**RE: Juan Tabo Hills Estates**  
**Manhole 47**  
**Drainage Report Stamp Date: 5/10/18**  
**Revision Sheet Stamp Date: 5/23/18 (5, 5.2, 6R) & 6/6/18 (5.1)**  
**Hydrology File- M21D018; DRB# 1005278**

Below is a response to the comments dated 6/04/18 for the Storm Sewer at Juan Tabo Hills.

**RE: Juan Tabo Hills Estates  
Manhole 47  
Drainage Report Stamp Date: 5/10/18  
Revision Sheet Stamp Date: 5/23/18  
Hydrology File- M21D018; DRB# 1005278**

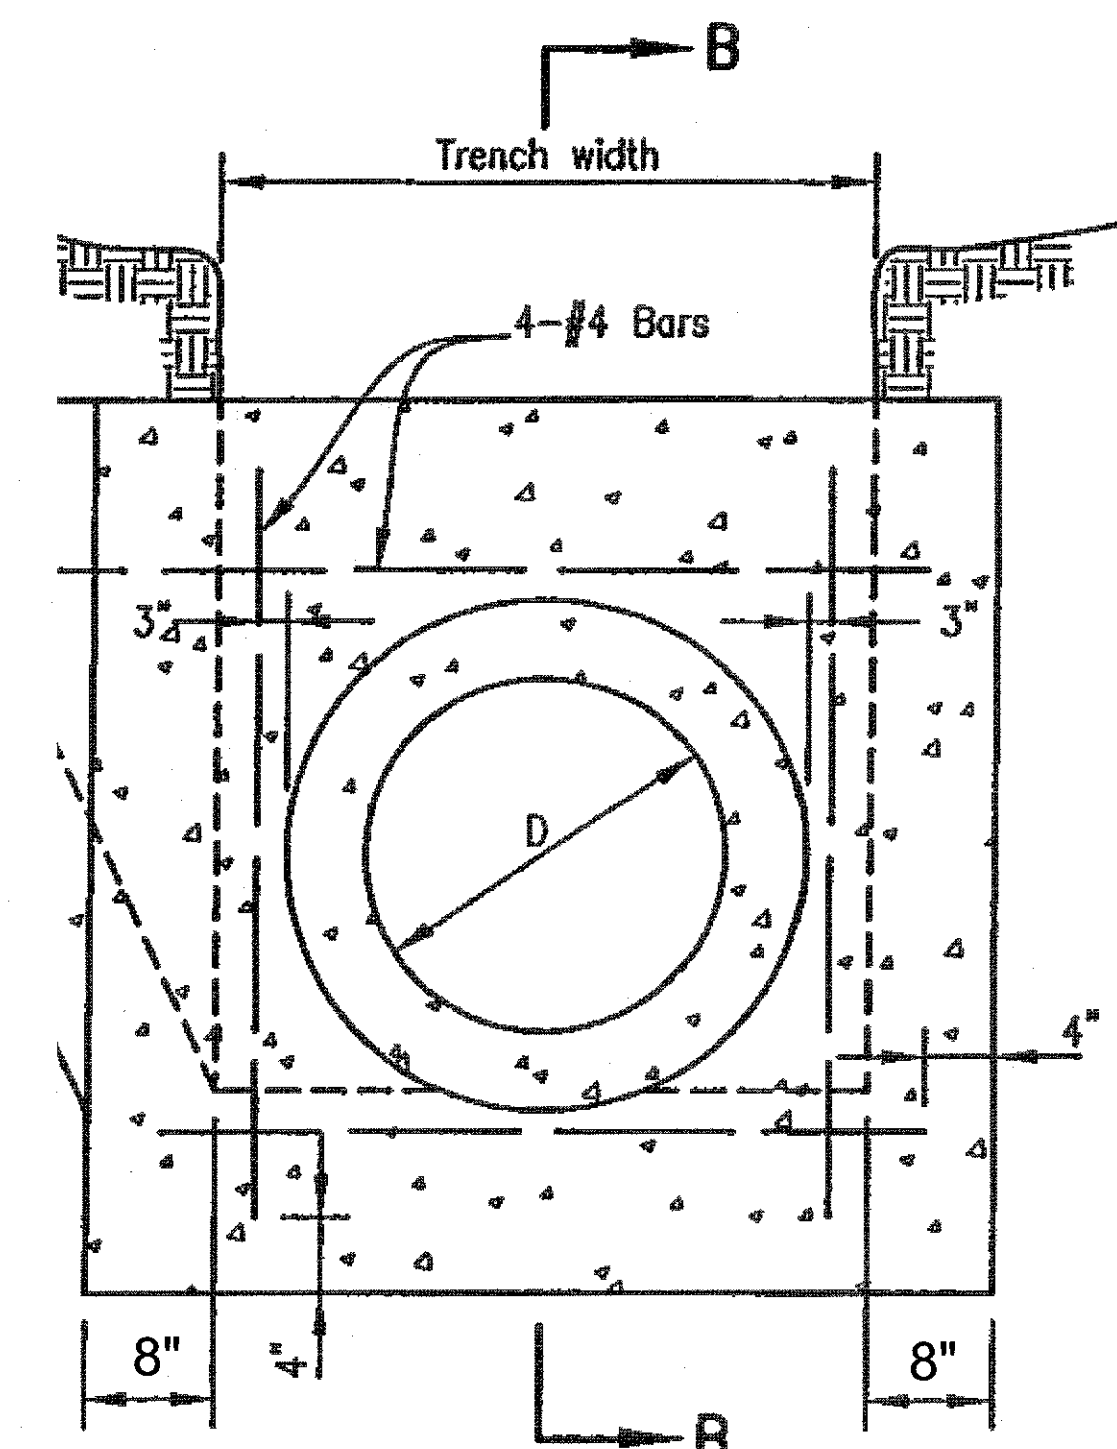
1. For RCP on steep slopes (greater than 20%), provide concrete pipe anchors, ~35' o.c. This must include a detail, complete with dimensional data, reinforcement if needed, and specifications. The CoA has no standard detail for this sort of thing, all build details will need to be provided by the Engineer.

1. A detail for the proposed concrete pipe anchors has been added to sheet 5.1 of 6 for all RCP with slopes greater than 20%, complete with dimensional data, reinforcement and specifications.

1. CONCRETE PIPE ANCHORS SHALL BE CONSTRUCTED USING FORMS WHEN STORM DRAINS ARE CONSTRUCTED WITH SLOPES 20% OR GREATER
2. CENTER TO MAXIMUM SPACING OF CONCRETE PIPE ANCHORS SHALL BE:

SLOPE	SPACING (ON SLOPE)
20-34%	35' O.C.
3. ALL REINFORCING STEEL SHALL BE #4 BAR.
